# Access Compliance Report

## Public Rights-of-Way

Intersection ID: 30248	Main Street: OLD_IRNSIDE_DR	Cross Street: WOLVERINE_CT	Location: NE
ADA ID: 16CF6D2581C9	Ramp Type: BlendTrans1	Initial Pass/Fail: Fail	Overall Compliance: No
Severity Score: 12.5			
Codes/Mitigation Info/Possible Solution		Field Measurements/Component Compliance

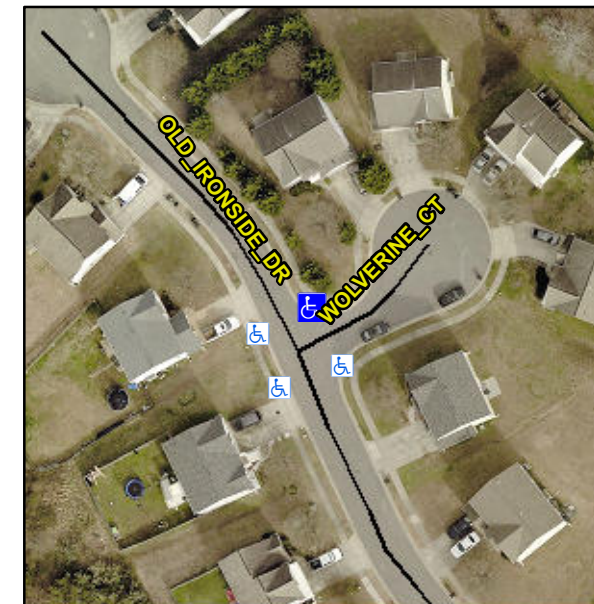
**CURB WIDTH 46.5**

**Not Found, R304.5.3**

Compliance	Description	Data	Compliance	Description	Data
N/A	Ramp Length (in)	48.0	Yes	BlendTrans Slope (%)	4.2
Yes	Ramp Width (in)	49.0	No	BlendTrans XSlope (%)	6.0
N/A	Flare Type LT	N/A	N/A	Flare Type RT	N/A
N/A	Flare Slope LT (%)	N/A	N/A	Flare Slope RT (%)	N/A
N/A	Flare Traversable LT?	N/A	N/A	Flare Traversable RT?	N/A
N/A	Landing Length (in)	N/A	N/A	DWS Provided?	N/A
N/A	Landing Width (in)	N/A	N/A	DWS Contrast?	N/A
N/A	Landing Slope (%)	N/A	N/A	DWS Length (in)	N/A
N/A	Landing X Slope (%)	N/A	N/A	DWS Full Width?	N/A
N/A	Landing Curb? (Y/N)	N/A	N/A	DWS Offset (in)	N/A
N/A	Shared Landing?	N/A			
N/A	Gutter Ponding?	N/A	N/A	Gutter Slope (%)	N/A
N/A	Gutter Lip Ht (in)	N/A	N/A	Gutter X Slope (%)	N/A
N/A	Painted X Walk1?	No	N/A	Painted X Walk2?	No
	X Walk 1 Direction	To SW		X Walk 2 Direction	To SE
	X Walk 1 Width (in)	N/A		X Walk 2 Width (in)	N/A
	X Walk 1 Slope (%)	1.7		X Walk 2 Slope (%)	3.4
	X Walk 1 X Slope (%)	7.5		X Walk 2 X Slope (%)	1.9

**Remove & Replace Curb Ramp With Two New Directional Ramps or Equivalent.**
